Cumberland County Subdivision and Land Development Review Report

Municipality:	<u>South Middleton</u>	Surveyor/ Engineer:	<u>Michael C. D'Angelo P.L.S.</u>	Owner/ Developer:	<u>David and Jody Boore</u>
Plat Title:	<u>David and Jody Boore</u>				
Plat Status:	<u>Final</u>	Plat Type:	<u>Subdivision</u>		
# of New Lots:	<u> </u>	# of New Dwelling Units:	<u> </u>	New Acreage Subdivided/Developed:	<u>1.5</u>
				Total Tract Acreage:	<u>9.21</u>
Zoning District:	<u>AC</u>	Proposed Land Use:	<u>Residential</u>		
Date Received:	<u>9/24/2020</u>	County Review:	<u>10/9/2020</u>	Reviewed by:	<u>SH</u>
				Checked by:	<u> </u>

**LOT ADDITION
 FINAL SUBDIVISION PLAN
 EXISTING CONDITIONS
 PER SHEET 2 OF 3
 PAN BOOK 91 PAGE 76**

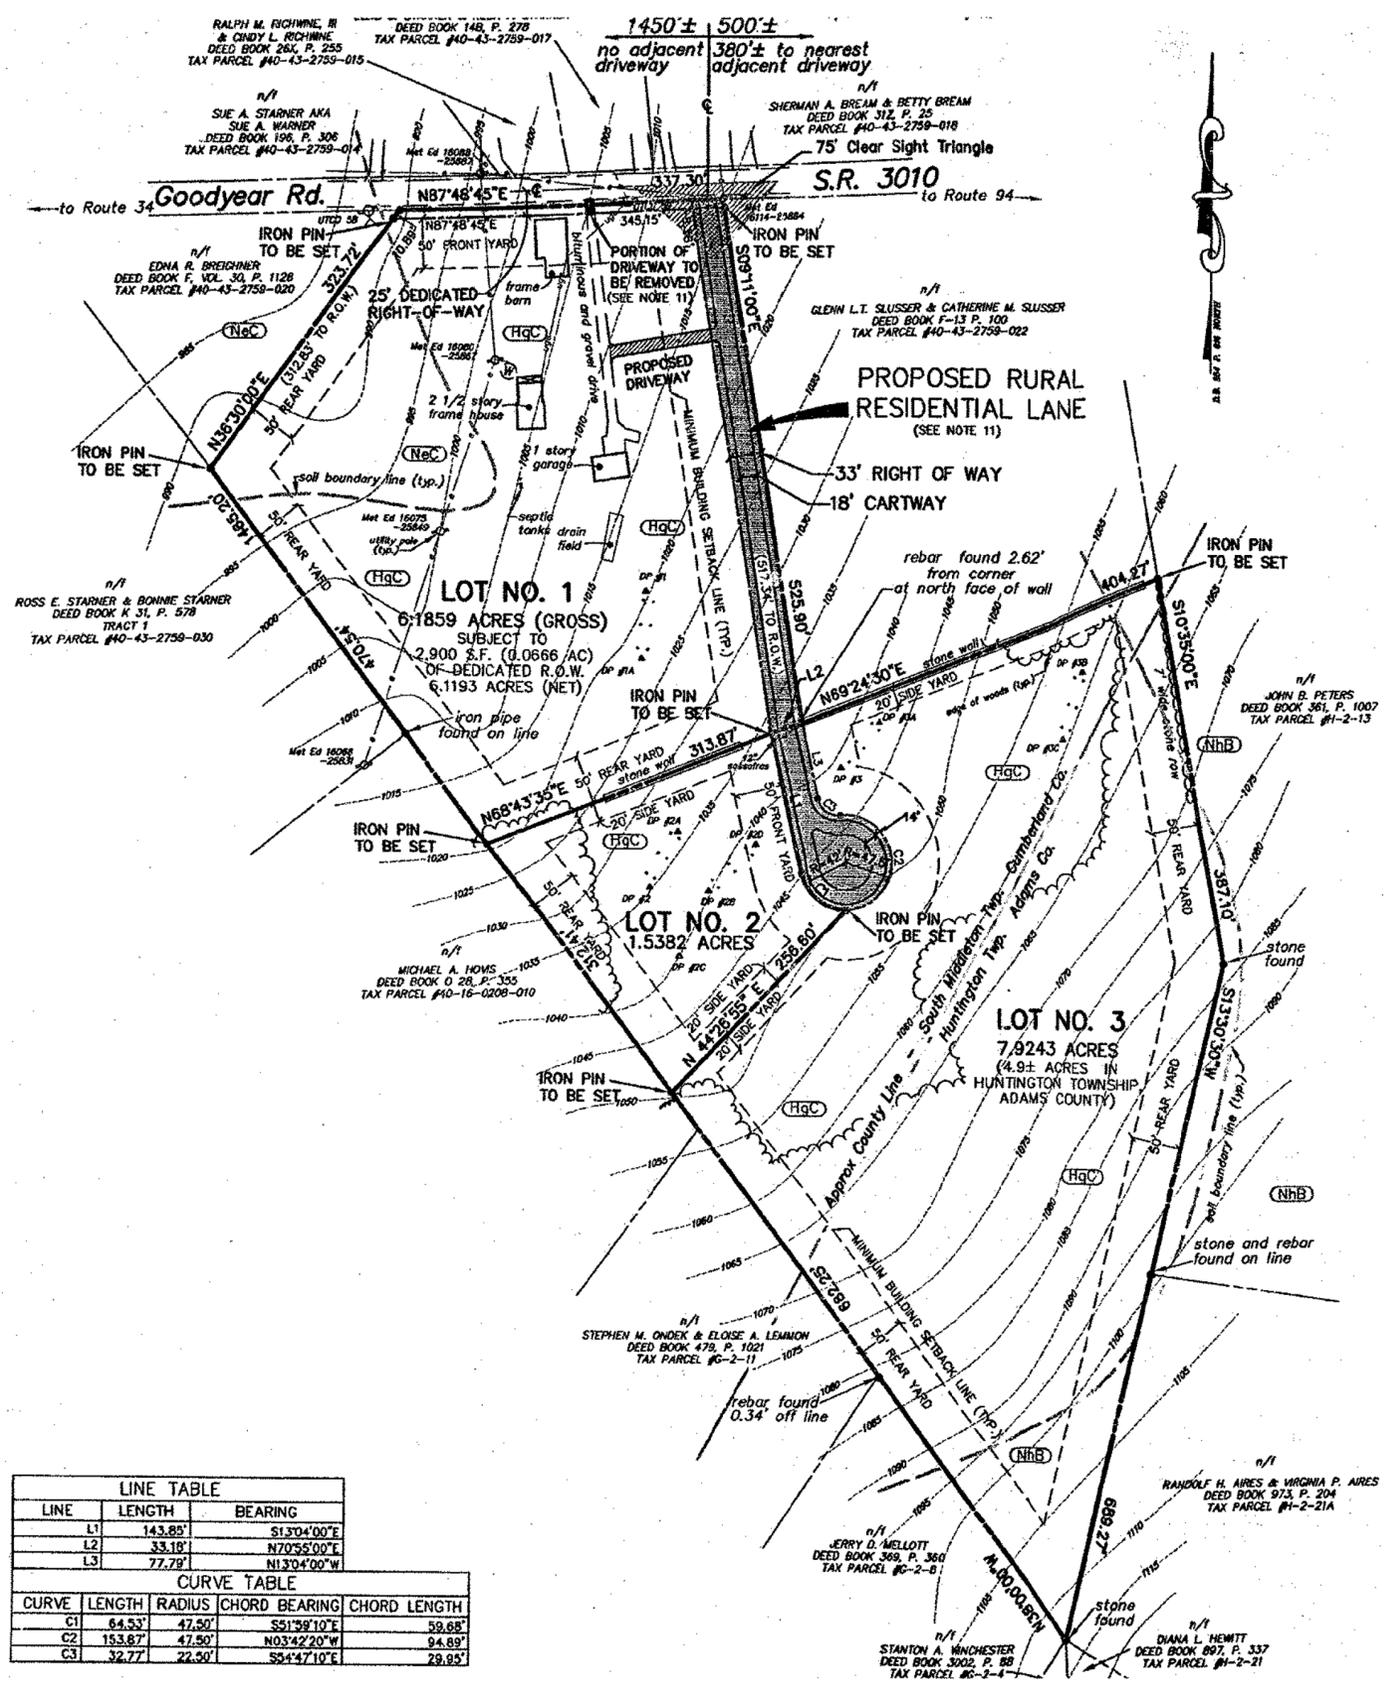
1. The purpose of the location map is to locate the property being subdivided. Recommend a larger map, or a smaller scale, that identifies the location of the property (SLDO 501.B.8).

2. The South Middleton Township Zoning Ordinance limits the number of dwellings upon each parcel as it existed on 9/21/1999. It appears that all of the dwellings permitted on the two lots will be conveyed to the owner of new Lot #2. The plan should include a note to clarify (Zoning 601.6.B).

3. The plan should include all lot and area regulations found in the South Middleton Township Zoning Ordinance (Zoning 601.6.D). The plan should include proposed dimensions to verify compliance.
